Appendix II-E
Form 2 Packages

CU Certification of Completion

CU BACKFILL/ENGINEERED CAP COMPLETION APPROVAL - FORM 2						
Reporting Date	11/24/2009	Placement Start Date			10/28/2009	
CU Number	1	Placement End Date			11/20/2009	
Approximate CU Centroid	Northing	1616824.789	Easting	735165.184	NY State NAD 83	
CU Size	3.39	Acres				
Backfill Area	0	Acres				
Cap Area	3.39	Acres				
Backfill Surface Mean Tri+ PCBs Concentration (when required)		NA		mg/kg		
Number of nodes sampled		NA		mg/kg		
Backfill NA	Type of Backfill NONE	Reference to appropriate drawings attached to Approval Form 1				
Cap X	Type of Cap Type "B" Medium Velocity Cap Type "B" High Velocity Cap	Reference to appropriate drawings attached to Approval Form 1 CU1 Backfill and Cap Plan, 11/4/09				
CU Checklist		Indicate one of the following			Reviewer Initial Acceptance

Narrative Summary of Backfill and Capping and EPA Backfill and Capping Agreements

**CU1-1 & CU1-2 TYPE "B" CAP ARMOR
STONE PLACEMENT NAVIGATION
CHANNEL ELEVATIONS**

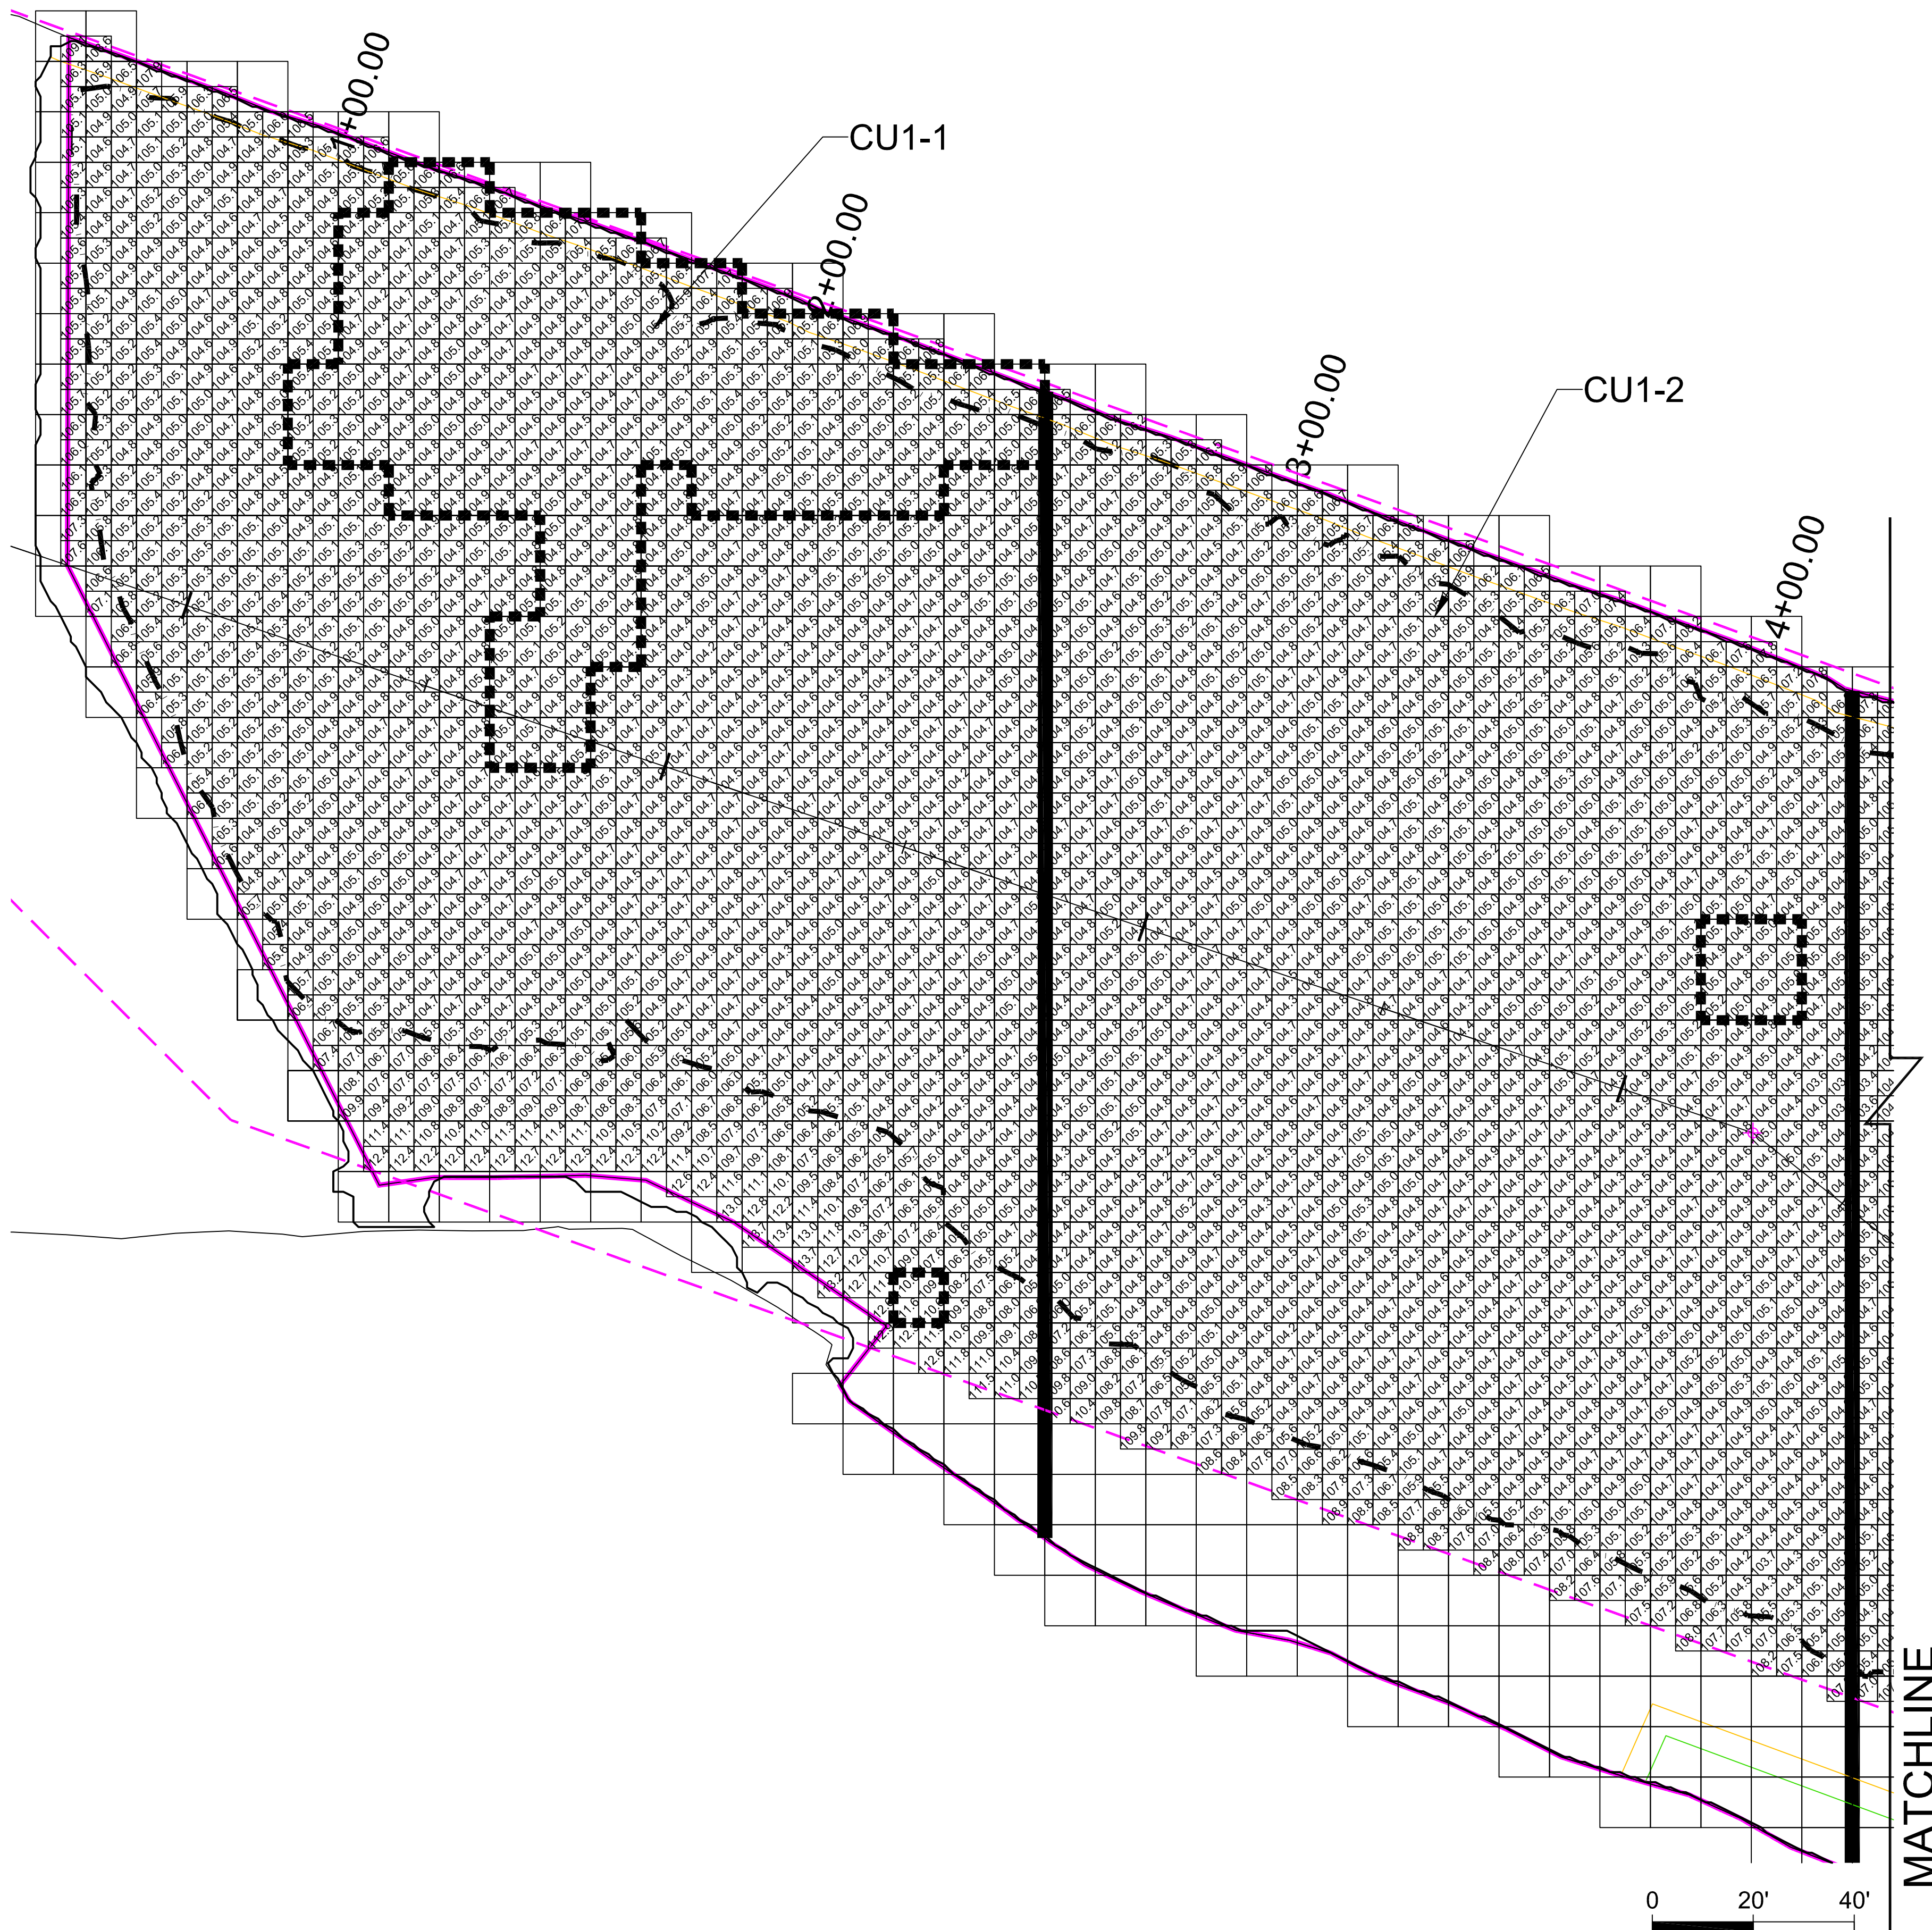
4. On November 20, 2009, GE provided final armor layer placement surveys to EPA via email. EPA informed GE on November 21, 2009, via email, that the armor layer thicknesses were acceptable. (See attached e-mail dated November 21, 2009.) The CU 1 Type "B" Cap Armor Layer Acceptance Survey drawing, dated November 21, 2009 is included in this package.

5. After placing Type O cobble armor in the high velocity Type "B" cap in the navigation channel areas it was observed that the required thickness of armor stone had not been obtained in some locations. In addition, there was not sufficient depth to place additional Type O material, given the diameter of the stone, and remain below the required 105.2' elevation. Similarly to the solution used in CU2, GE placed Type N material on top of the Type O armor stone to increase the thickness of high velocity Type "B" caps in areas of the Navigation Channel with depth restrictions.

Andrew,
Cap elevations look good for CU1.

DRAWING TITLE: CU2 BOND CREEK RFW DETAIL

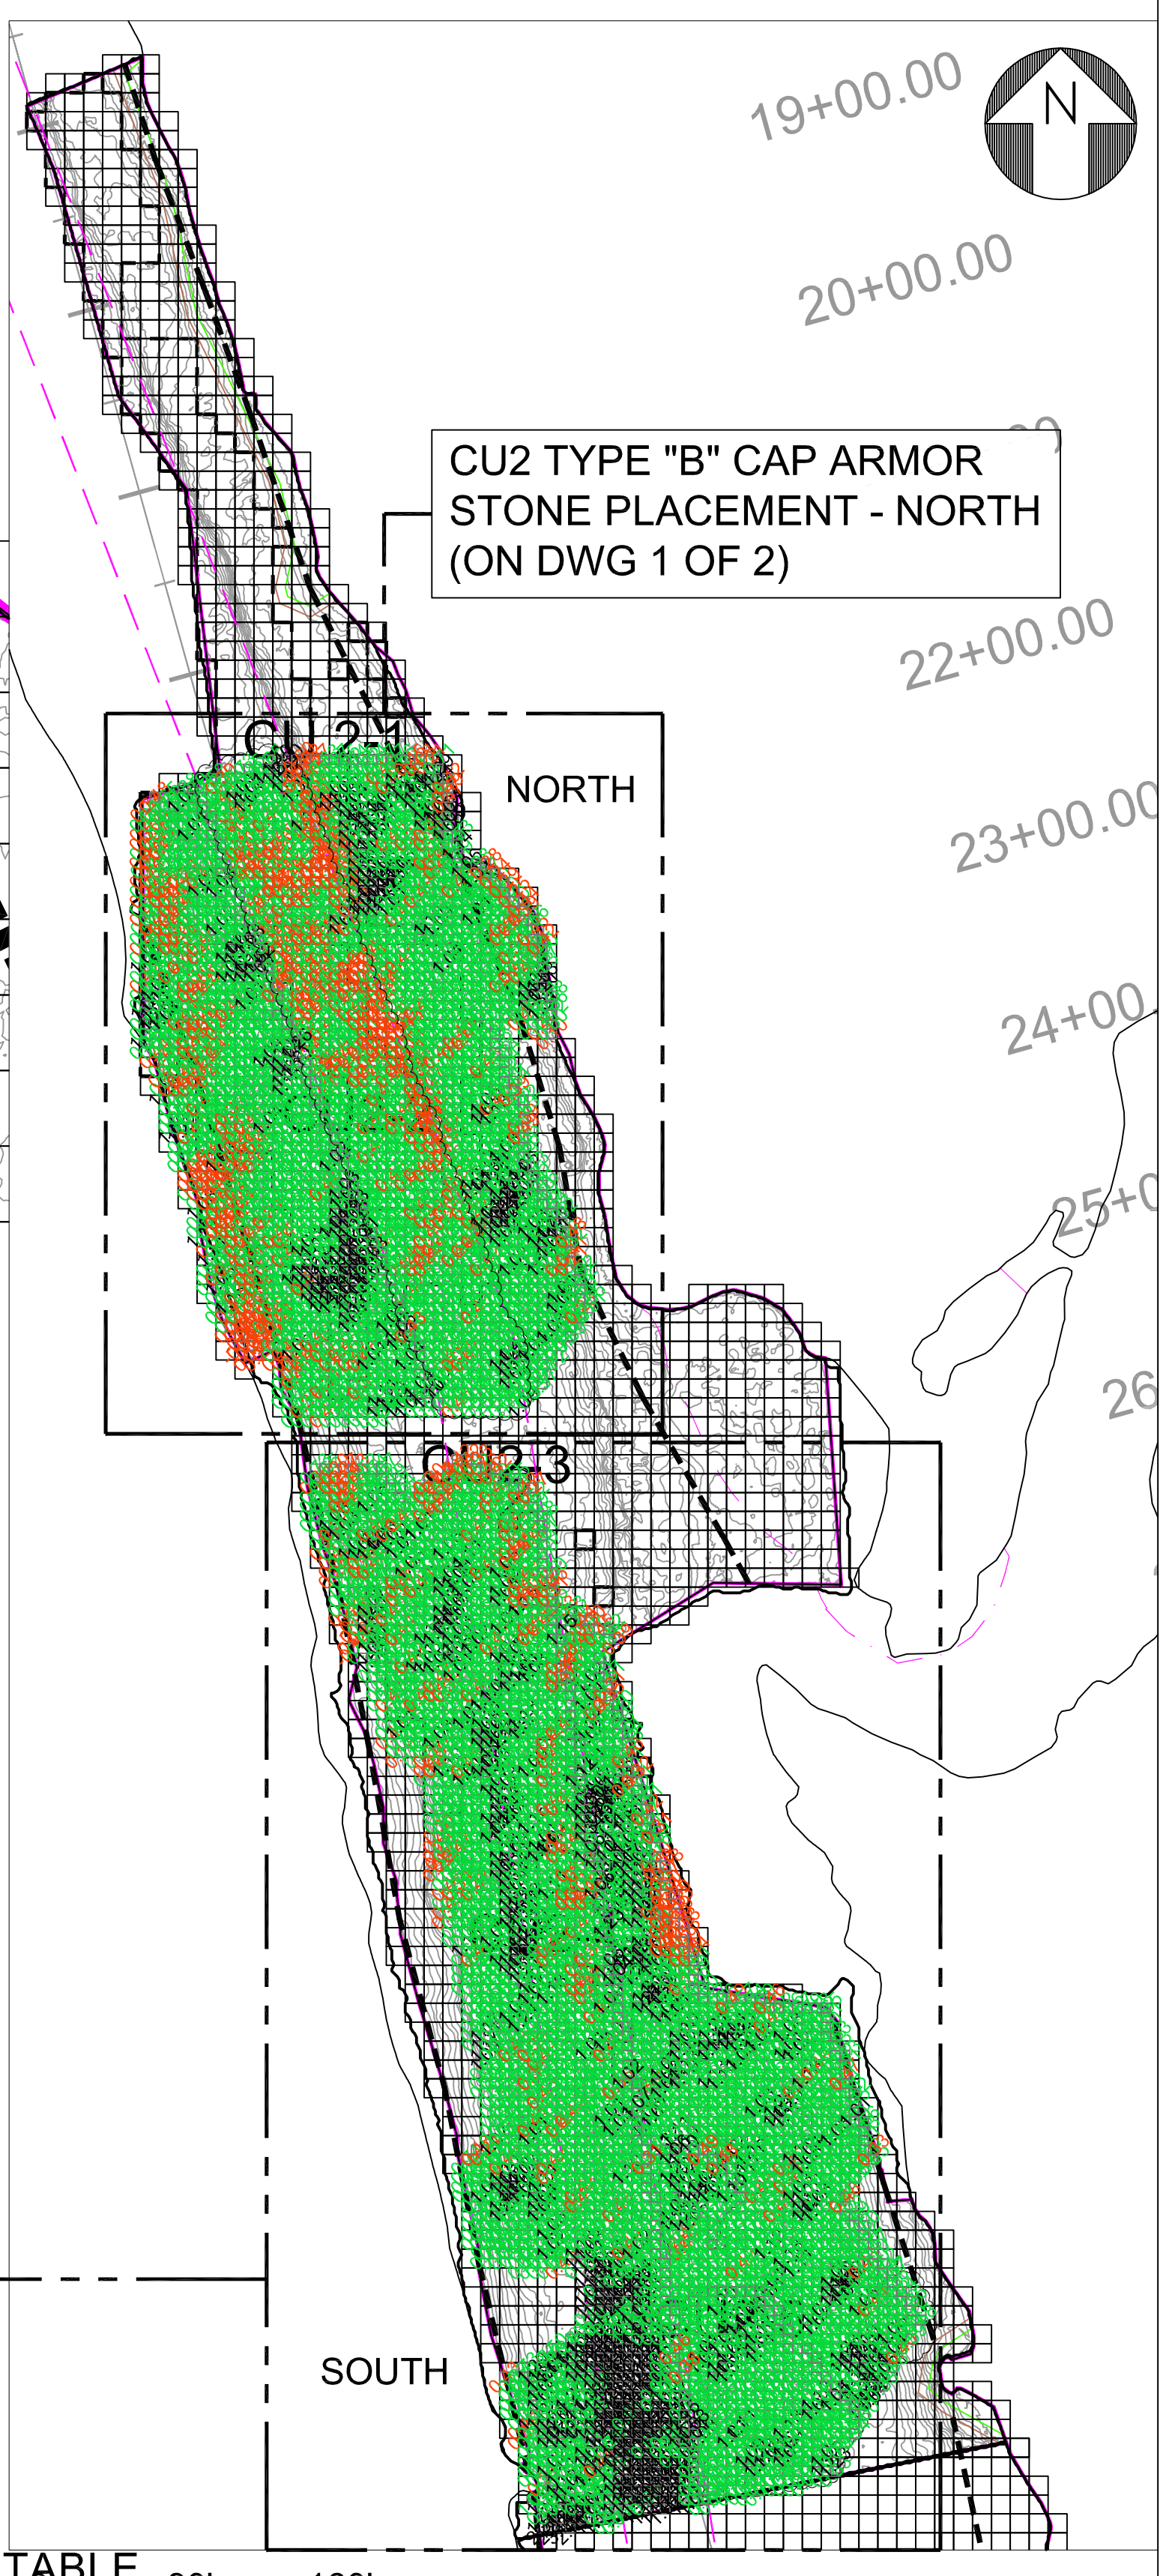
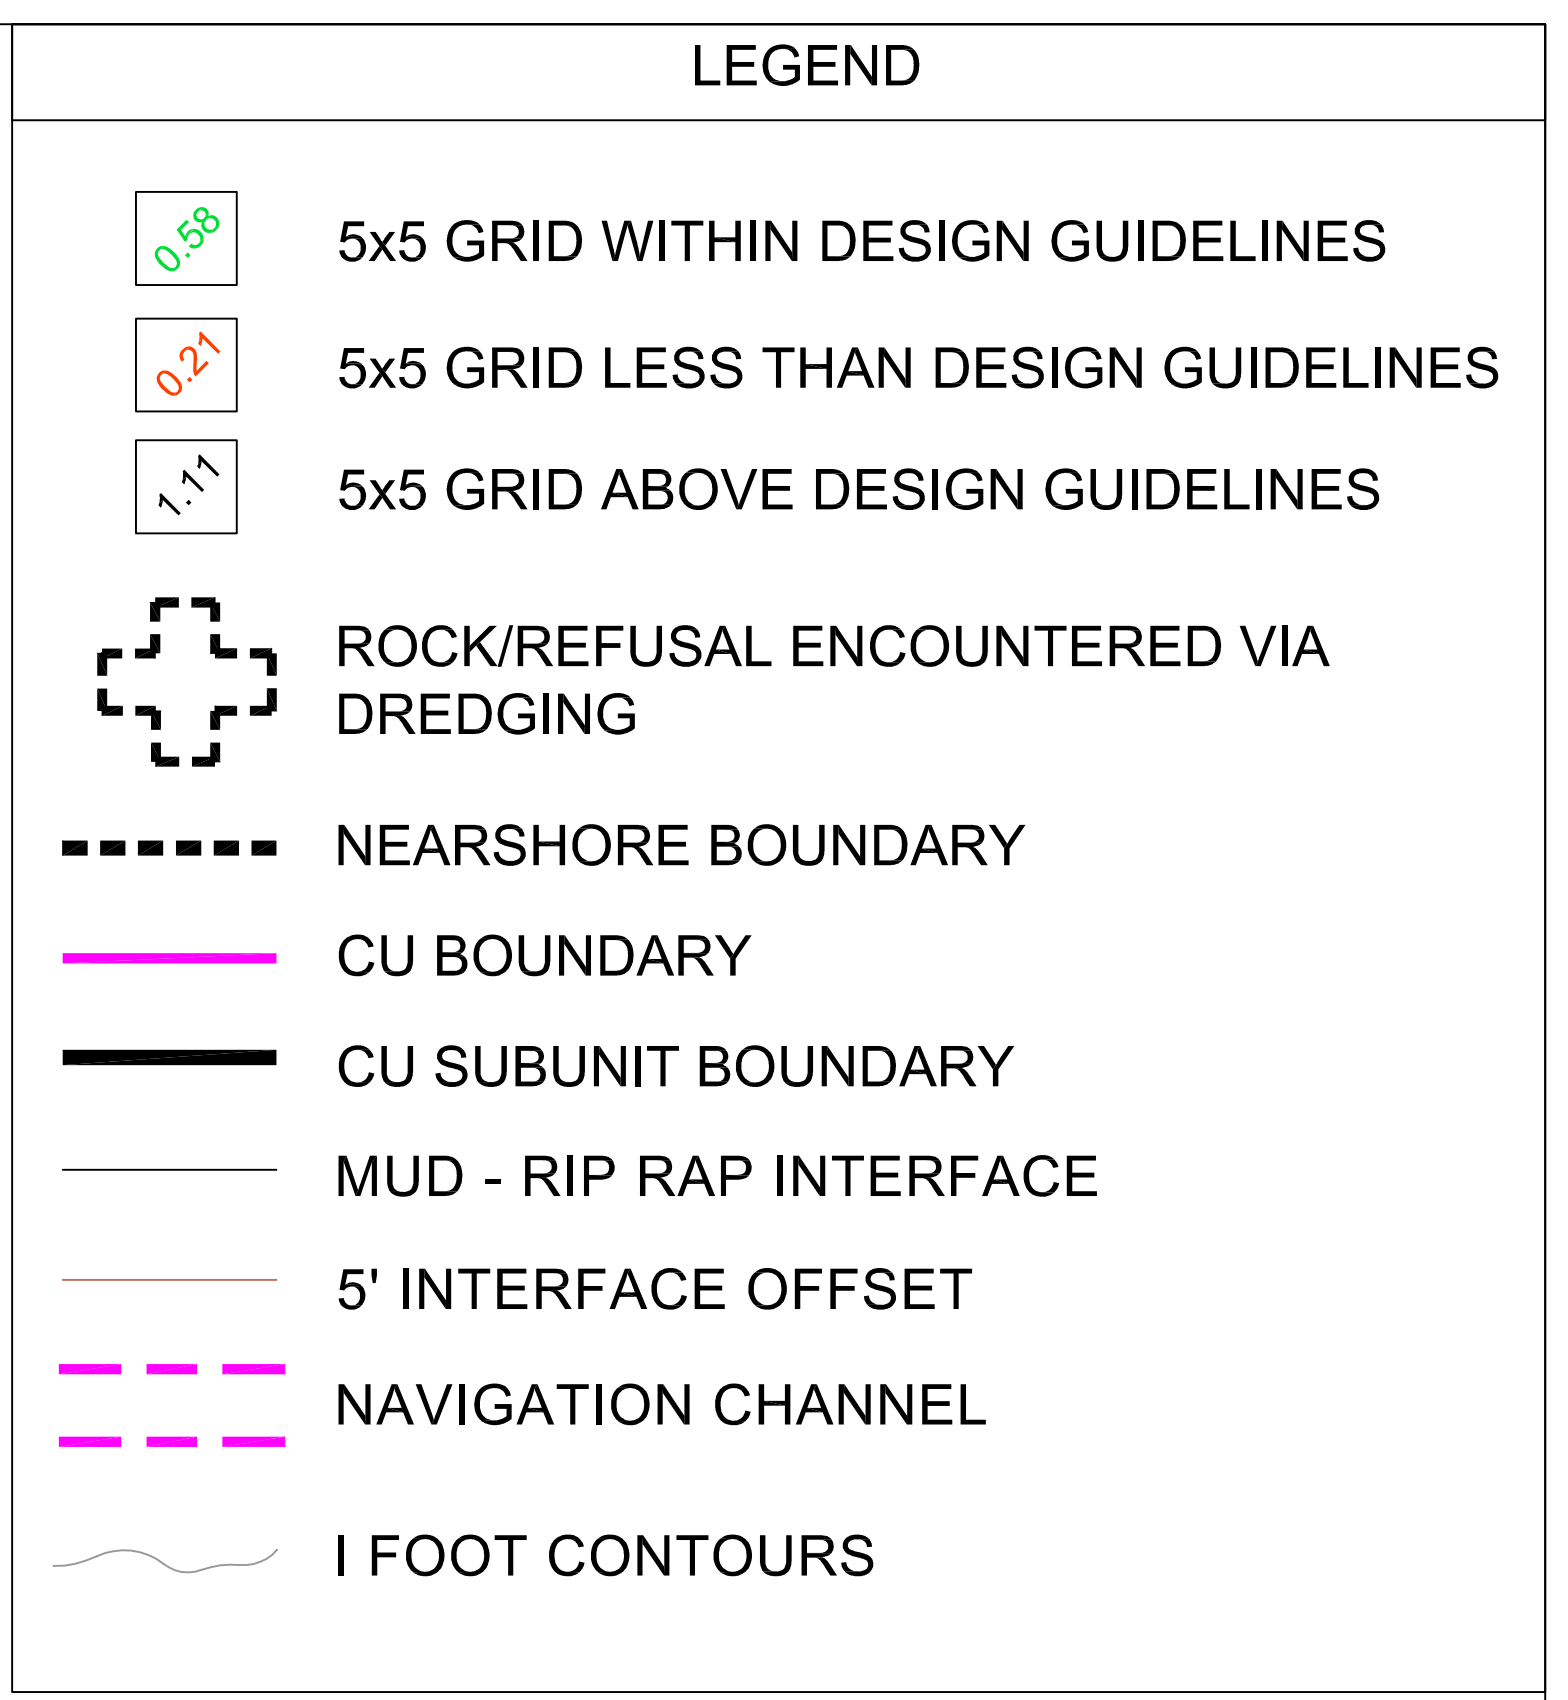
6. During a 3:00 PM meeting with EPA on November 13, 2009, GE presented a drawing and table showing the Riverine Fringing Wetland (RFW) area in Bond Creek. EPA agreed that backfill placement within the RFW area was acceptable. Table and drawing CU2 Bond Creek RFW Detail, dated November 11, 2009, is included in this package.
